A	APPROVED. PROCEED FOR MANUFACTURE/ CONSTRUCTION.
B	✓ APPROVED WITH COMMENTS. PROCEED TO MANUFACTURE/ CONSTRUCTION SUBJECT TO COMPLIANCE OF ALL COMMENTS AND RESUBMIT THE DOCUMENTS FOR LEVEL A APPROVAL.
C	RESUBMIT AFTER INCORPORATION OF ALL COMMENTS FOR REVIEW.
D	REJECTED. MAKE A RESUBMISSION ALTOGETHER FOR REVIEW.

PROJECT: NEW GMR INTERNATIONAL AIRPORT PHASE-3A DEVELOPMENT WORKS

TITLE:
SHOP DRAWING
Building: ARFF4
ARFF4 MEGADOOR
8760 X 5400 (RS7)

DRAWING No. DIAL-LT-Q-UTL-A-10-101 SHEET

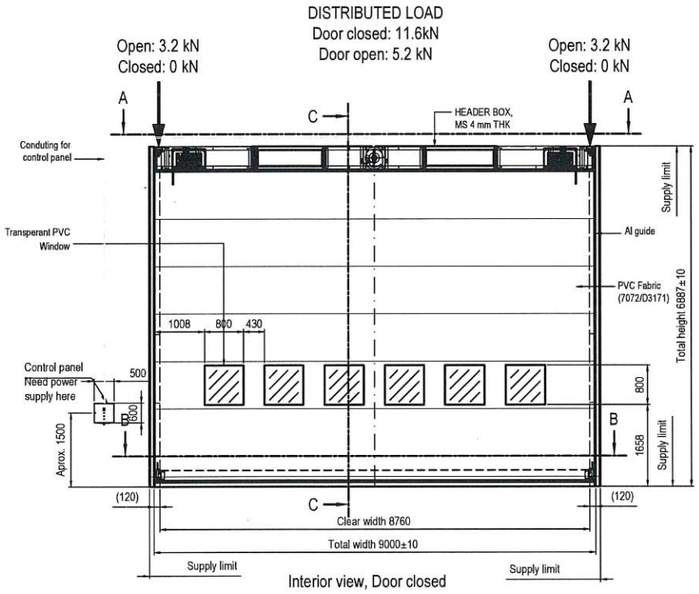
Remove old position lines from drawing

There is no wall at this location. Re-locate Control Panel at column face

There is no wall at this location. Relocate Control panel at column face.

Need to be shifted for clearance from door

Remove lines from drawing. Show current position of Roll-up fabric on plan

- Show roll-up fabric in plan with proper numbering & dimensions
- Submit this drawing also with drawing format & number.

DETAIL B, SCALE (1:10)

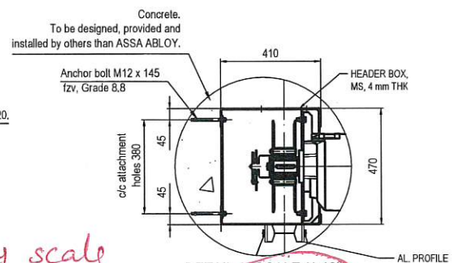
Why scale is made down from 1:5?

Cross check the detail scale. Make it 1:5

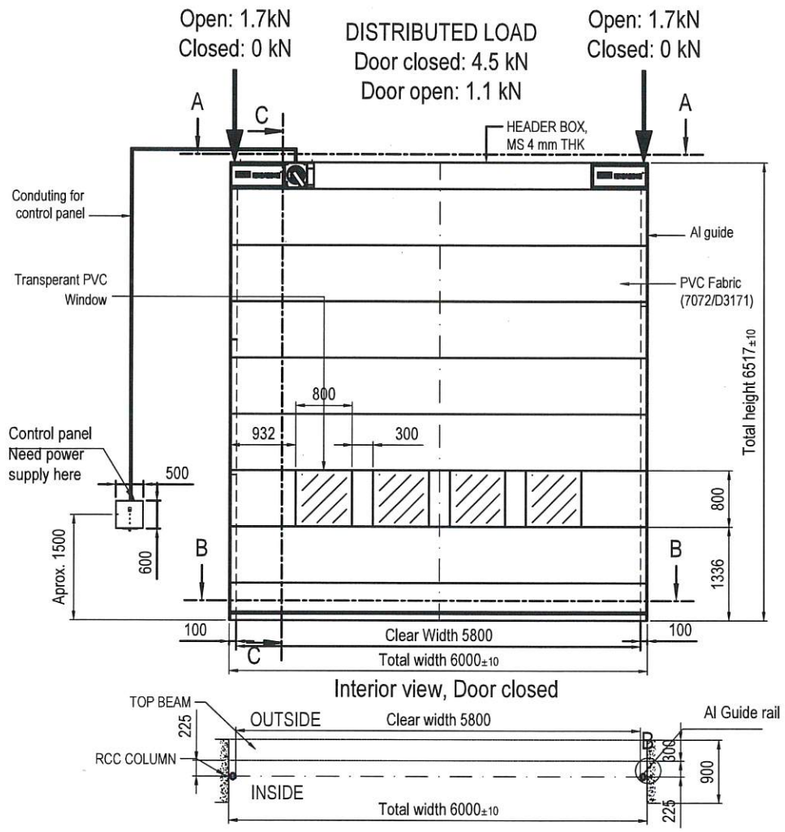
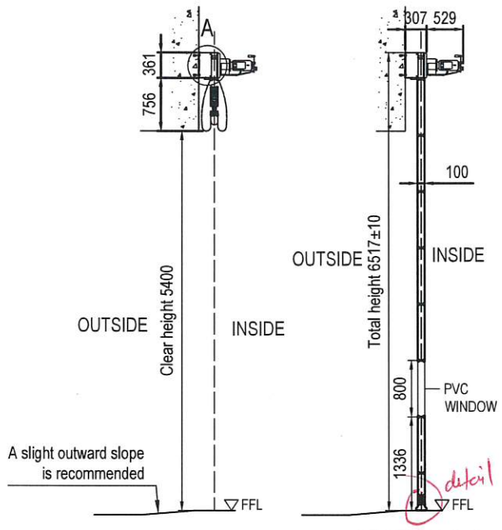
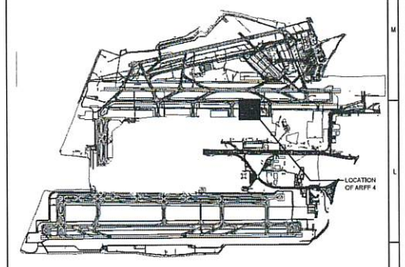
~~Ref~~ Given comments are not fully incorporated.

Check Scale

Check Scale

Correct the sequence

Provide both/bottom detail

Cable detail to be mentioned in drawing

Mention Vendors name

- All material & finishes shown in shop drawings are subject to MAS/ sample approved by DIAL.
- Previous comments are not fully incorporated.
- Please submit the final shop drawings to DIAL for approval.
- Details are not as per scale. Please correct.

DETAIL B, SCALE (1:5) cross check detail scale

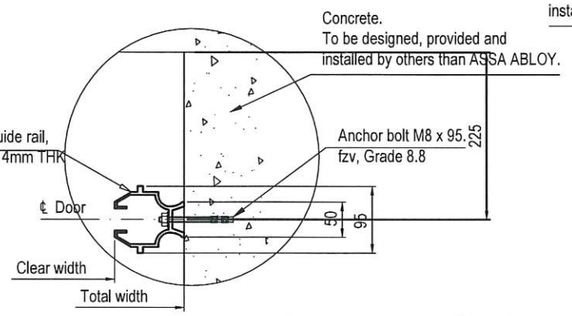
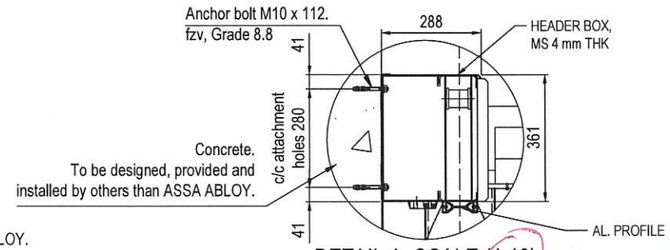
DETAIL A, SCALE (1:10) Cross check detail scale

DRAWING No. DIAL-LT-Q-UTL-A-10-102

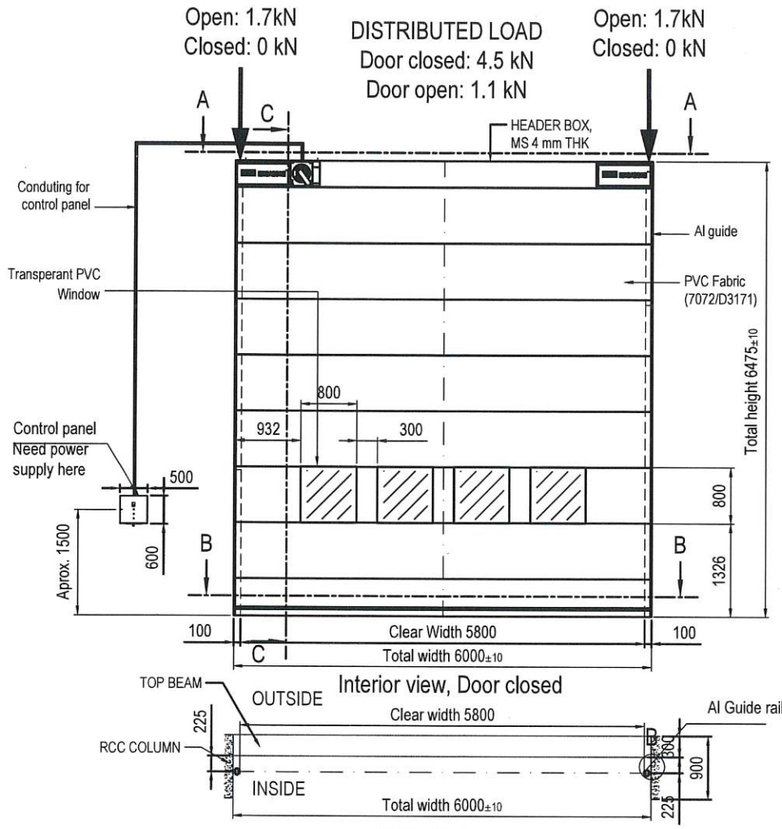
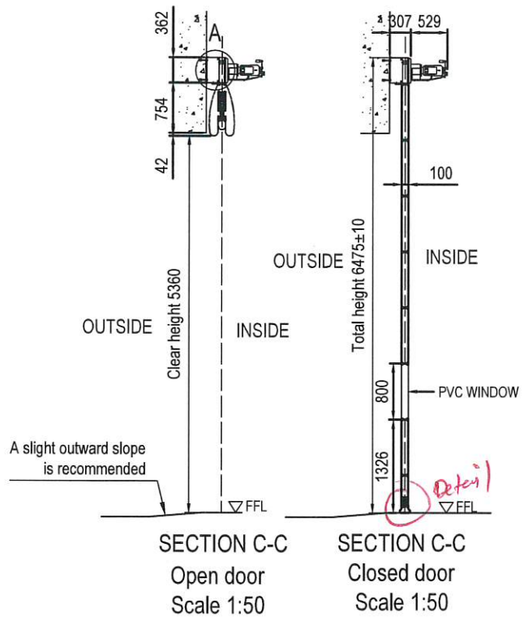
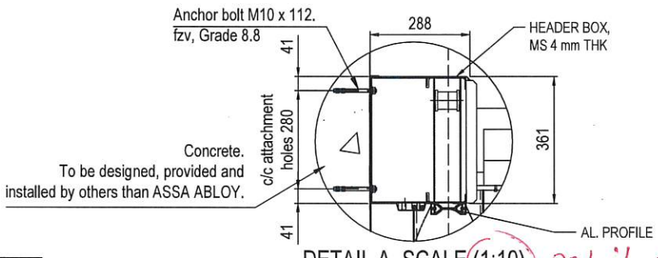
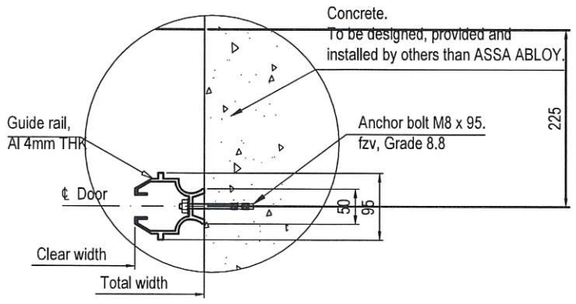
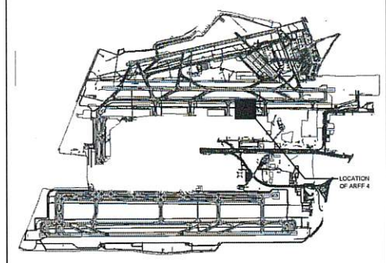
Refer general comments given on drawing no. A-10-101

TITLE: ARFF5 MEGADOOR 8760 X 4988 (RS7)
SCALE 1:50
DRAWING No. DIAL-LT-Q-UTL-A-10-104
SIZE A3
REV. B
PROJECTION FIRST ANGLE
RELEASED FOR ☐ PRELIMINARY ☐ TENDER ☐ INFORMATION ☑ APPROVAL ☐ CONSTRUCTION

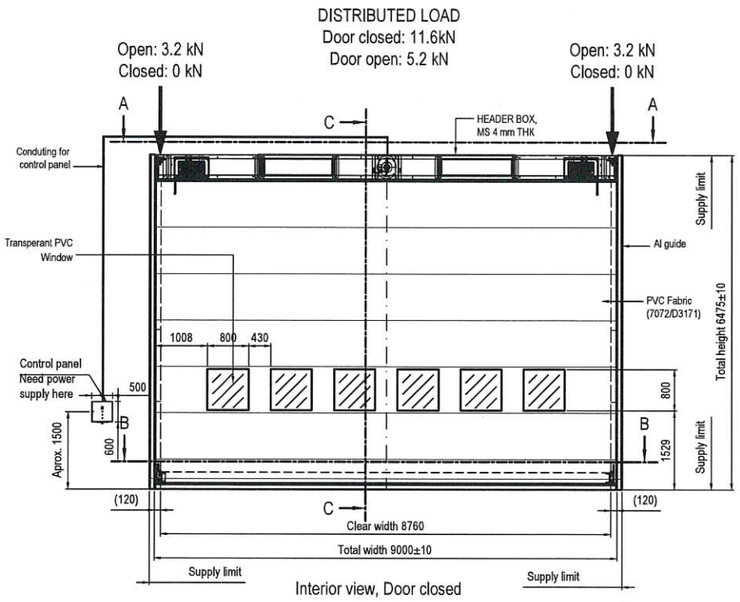
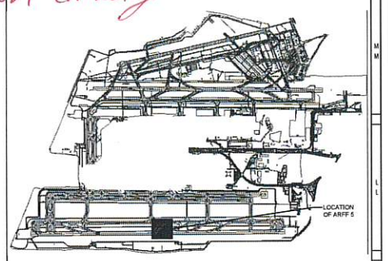
Refer general comments given on drawing no A-10-101

DETAIL C, SCALE (1:10)
ANCHOR POSITION FROM COLUMN

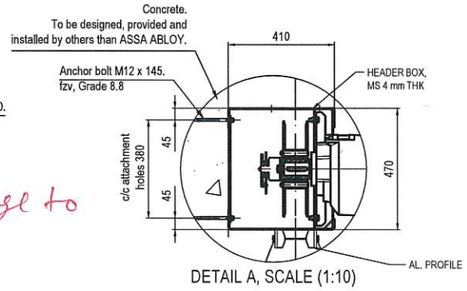
change to 1:5
